Re: North Campus Facilities

Subj: Change Proposal No. 233901-0008

We respectfully submit our proposal for an increase to our contract in the amount of \$0 (zero) dollars to provide Adding Bollards to Transformer Pads Per RFI 040 for the above referenced project.

RFI NO: 40

Attachments: Utilities Mark-up

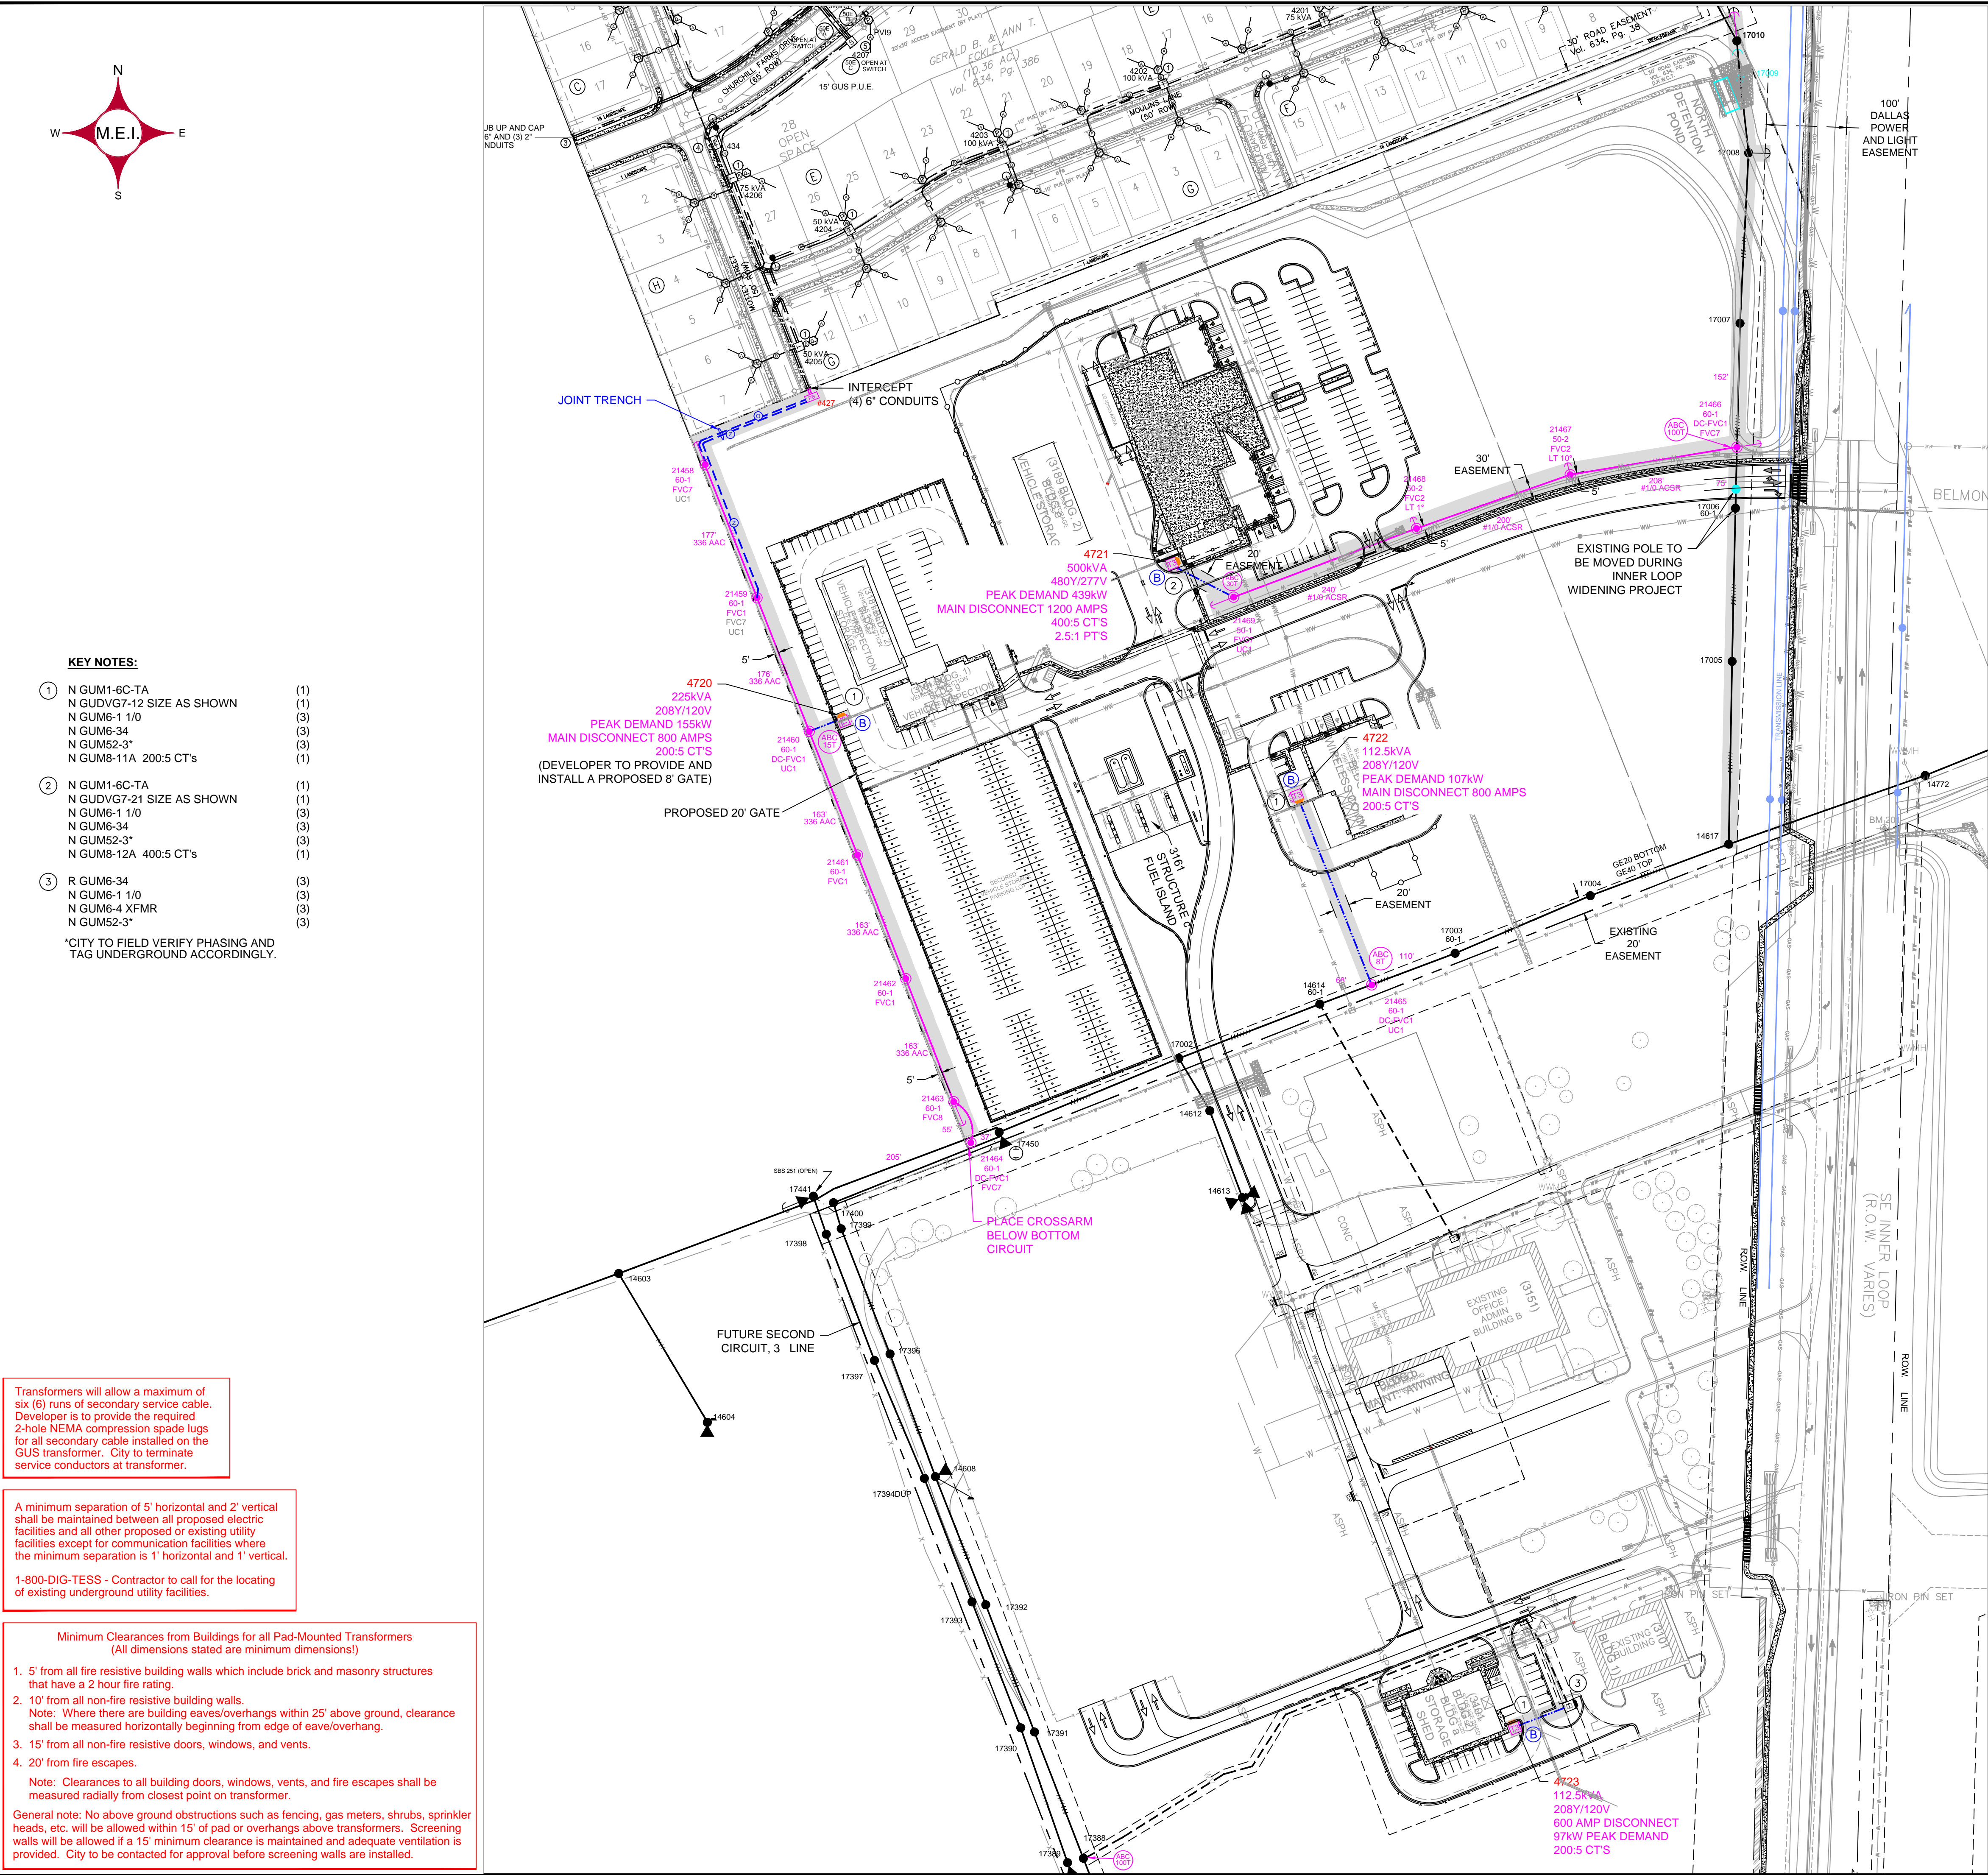
In the attached Power Pole layout, the City of Georgetown utilities run directly on top of the water line at the North side of Drive A. Please advise.

Also, there is to be a guy wire running directly across sidewalk based on coordinates captured which tie back to the civil drawings. Please advise.

Please see the attached drawing showing the power poles in a new location 5 feet from the proposed water lines. The guy wires have been modified as well to not cross the side walks.

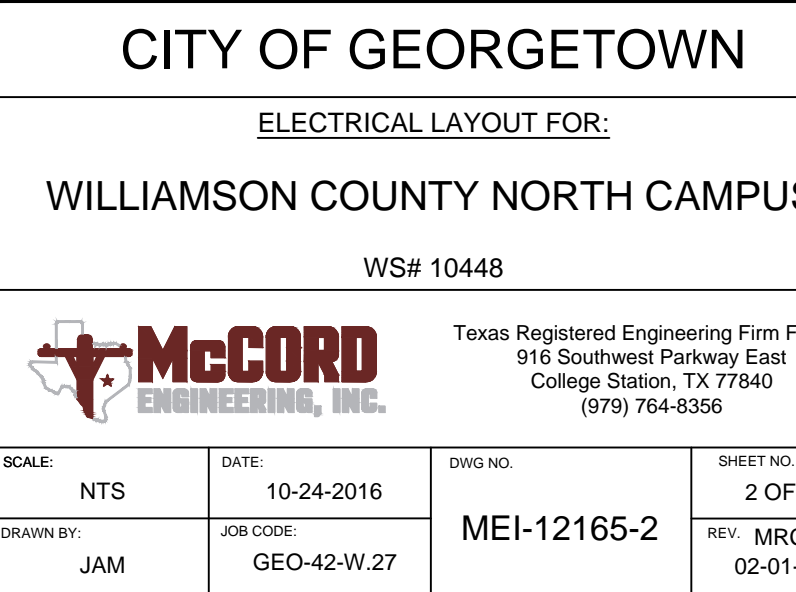
Please see bollard qty. below. I've attached RFI-040 which added additional bollard around the transformers. The detail for these bollards is shown on the last page of the RFI. Please provide pricing. Let me know if you have any questions.

Interior/ Exterior	Location	Qty.	Type
Ext.	Bldg. b	16	Cast-in-Place
	Bldg. d	12	Bolt-down
Ext.	Bldg. d	12	Cast-in-Place
	Bldg. e	13	Bolt-down
Ext.	Bldg. e	12	Cast-in-Place
Int.	Bldg. g	8	Bolt-down
Ext.	Bldg. g	8	Cast-in-Place
Ext.	Bldg. h @ Dumpster Pad	3	Bolt-down
	Bldg. h @ Oxy. Storage	4	Cast-in-Place
Ext.	XFMR's per RFI-040	24	Detail UGPB1.1
